February 20, 2018

RE: Main Pit Dump design revision

The following letter and figures outlines a revision to the Main Pit Dump Design.

Figure 3: Proposed design revision

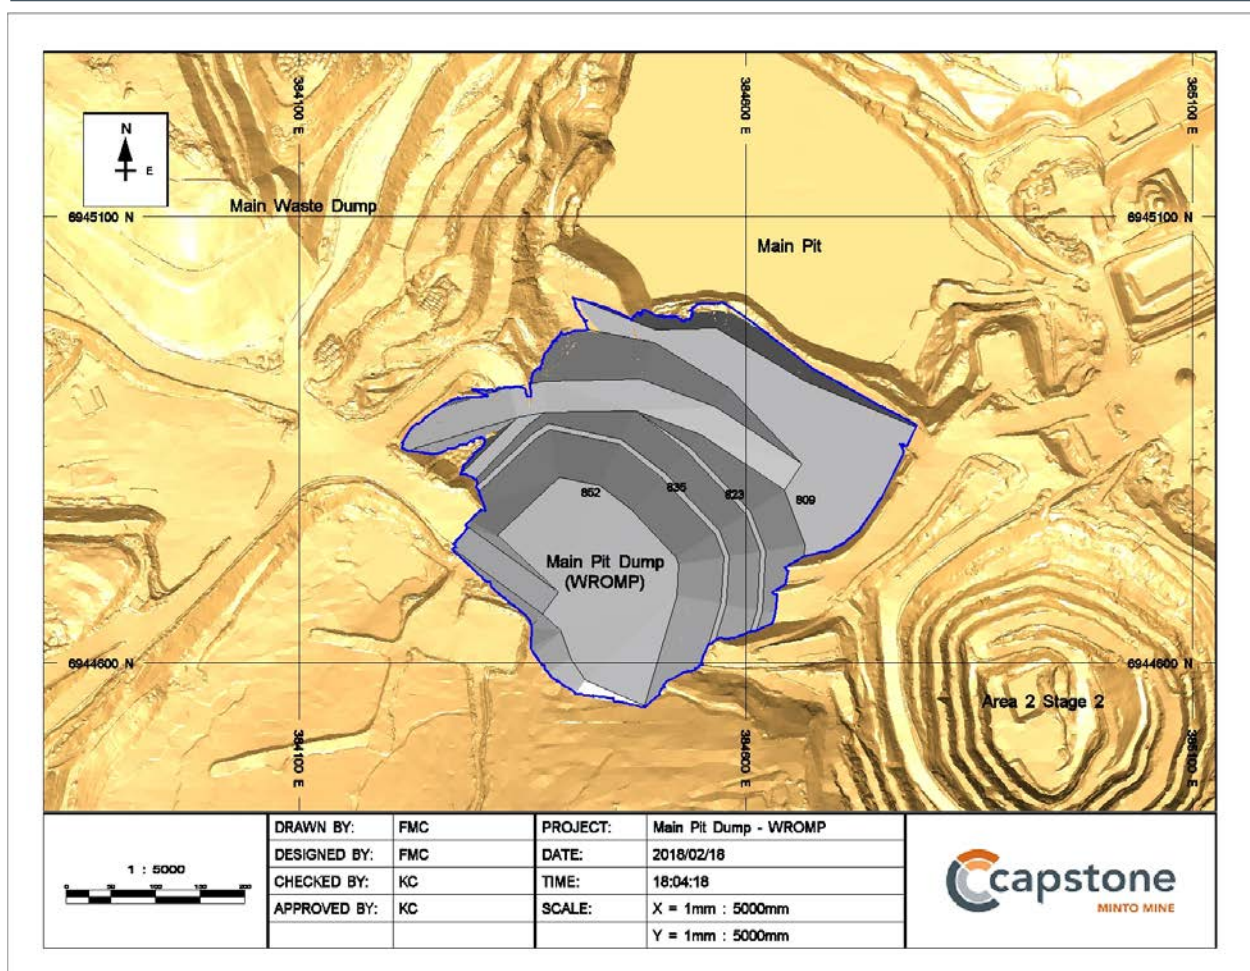
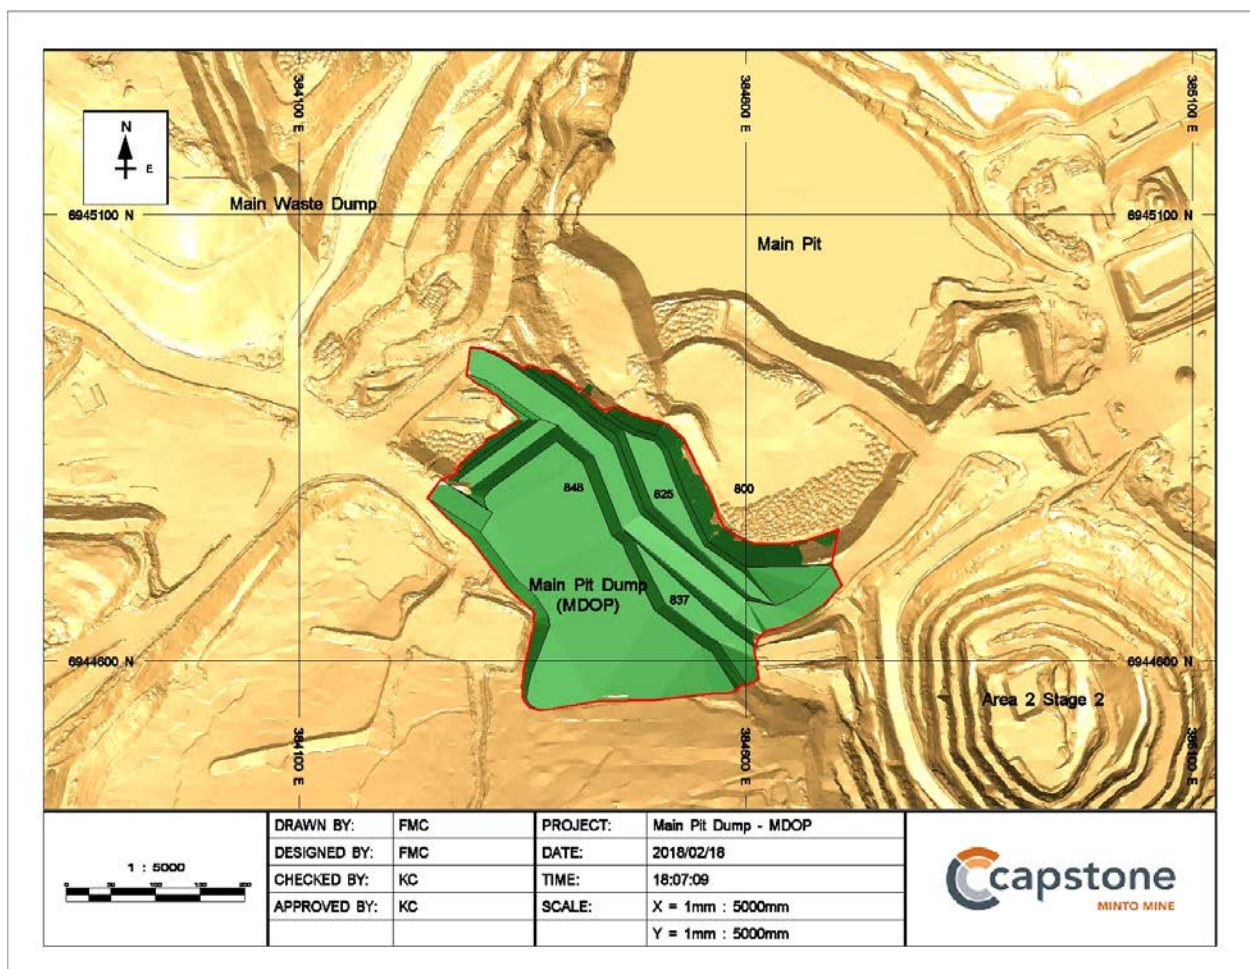
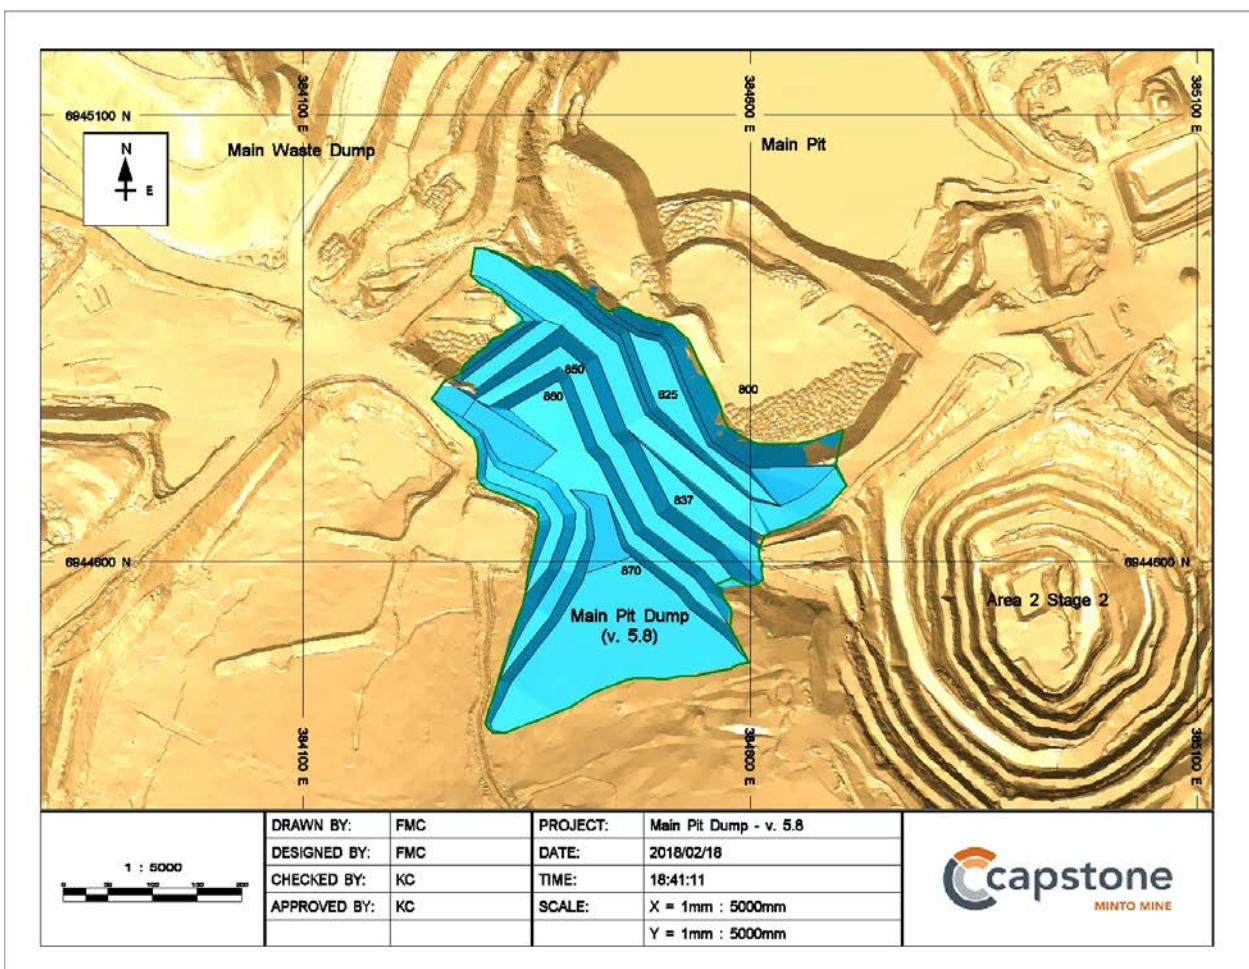
This document outlines the proposed design change which will increase the capacity to 1.67 Mm³ to account for the remaining waste rock from the Area 2 Stage 3 pit and ongoing waste release from underground development. This revision represents a 40% increase from the previous design (July 2017), but remains 23% smaller (by volume) than the originally permitted Phase V/VI design.

The proposed design, shown in Figure 3 and Appendix A, expands the dump slightly to the south with the objective of avoiding covering any SAT material, while staying within the permitted volume (2.17 Mm³). This results in a total capacity of 1.67 Mm³ and a change to the footprint of 2.77 hectares, shown in Figure 4, relative to the previous design (July 2017). All of the dump design parameters remain the same as the previous designs (Phase V/VI and July 2017). Stability analyses, included in Appendix B, have been updated and show no significant change.

Figure 1: Main Pit Dump Revision 5.8 Plan View

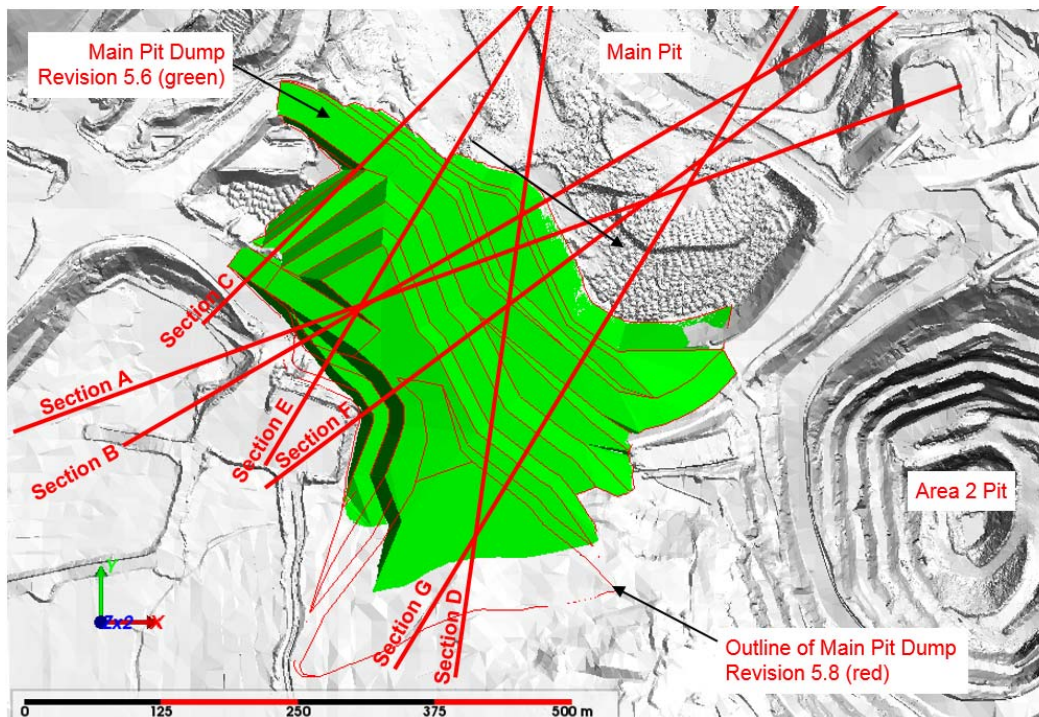
Figure 1 provides a plan view of the Revision 5.8 geometry (red lines) compared to the Revision 5.6 geometry (green), as well as the cross-section locations assessed in the Revision 5.6 stability analysis. Revision 5.8 includes an additional 10 m high waste rock lift that expands the dump footprint to the south and increases the ultimate crest elevation to approximately 870 m. As shown in Figure 1, Sections D and G are the two sections that are affected by the change in geometry and were reanalyzed as part of this assessment.

Revision 5.8 FOS values show no significant change compared to Revision 5.6 values and are above minimum requirements under static and pseudo-static loading conditions prior to closure.
